CITY OF ALBUQUERQUE

Planning Department
Brennon Williams, Interim Director

**RE: 9004 Sundial Pl SW
Grading and Drainage Plan
Engineer's Stamp Date: 9/13/25
Hydrology File: L09D013A
Case # HYDR-2025-00327**

ENGINEER'S SEAL	LOT 9-A SUNSET WEST SUB. UNIT 4 9004 SUNDIAL PL SW	DRAWN BY DEM
		DATE 9-12-25
	GRADING AND DRAINAGE PLAN	904 Sundial Pl SW
		SHEET # C1
DAVID SOULE P.E. #14522	ALBUQUERQUE, NM 87199 (505) 321-8099	JOB #

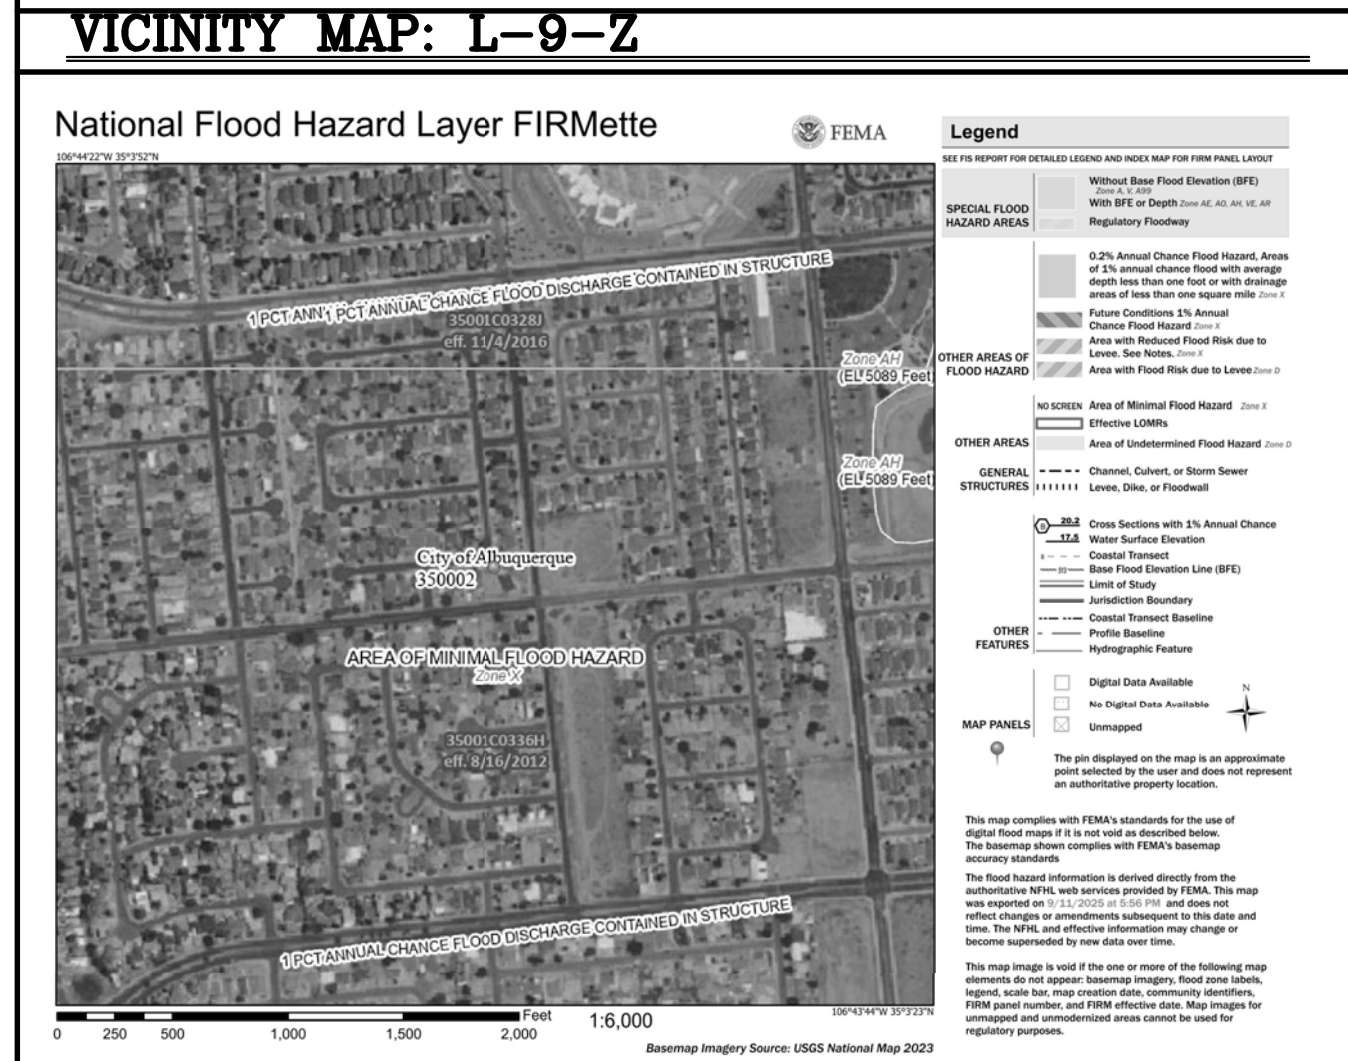
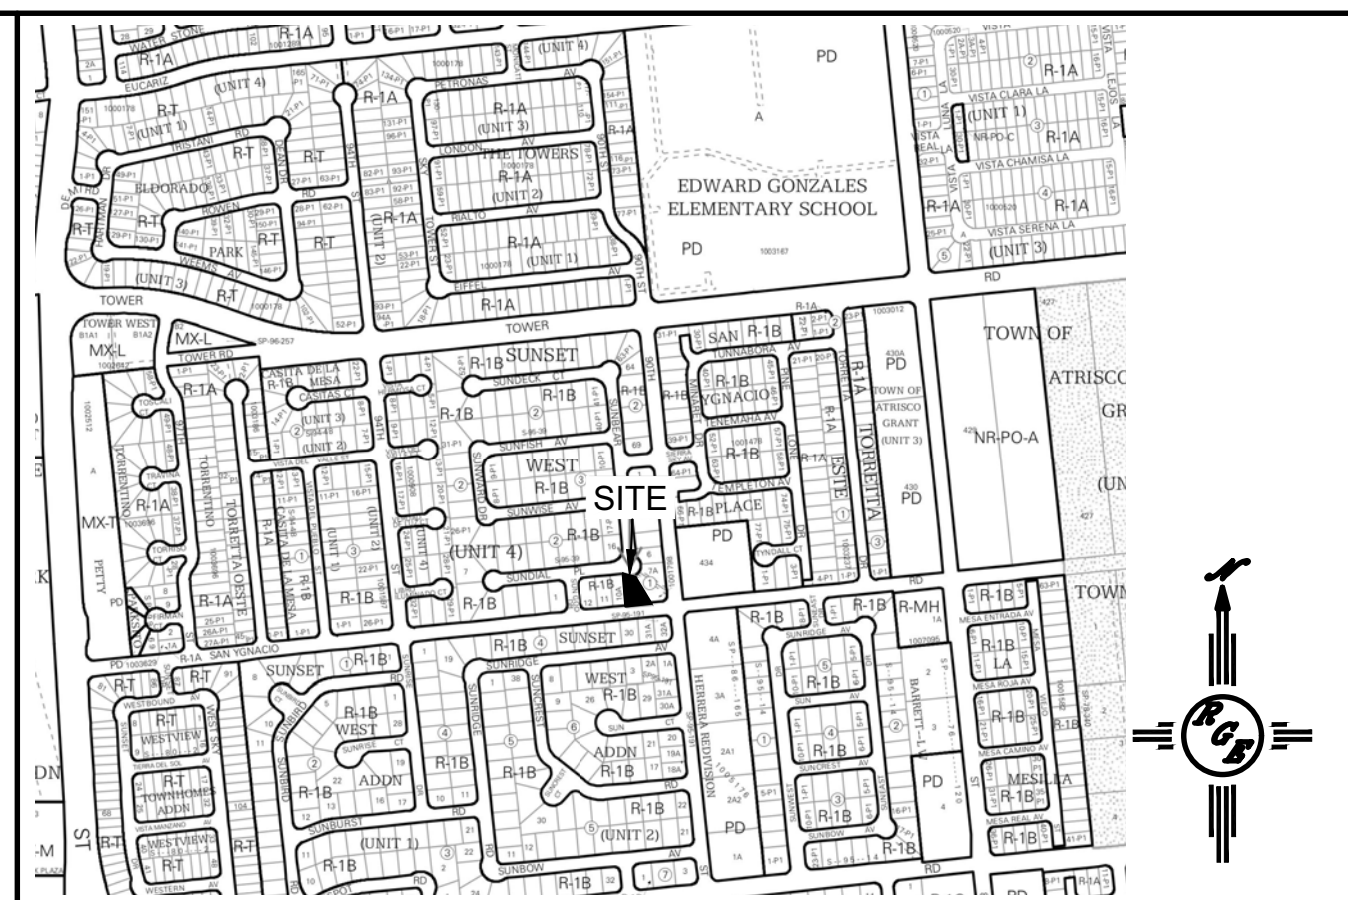
Based upon the information provided in your submittal received 9/14/2025, the Grading & Drainage Plans are approved for Building Permit. Please attach a copy of this approved plan in the construction sets for Building Permit processing along with a copy of this letter.

1. Engineer's Certification, per the DPM Part 6-14 (F): *Engineer's Certification Checklist For Non-Subdivision* is required.
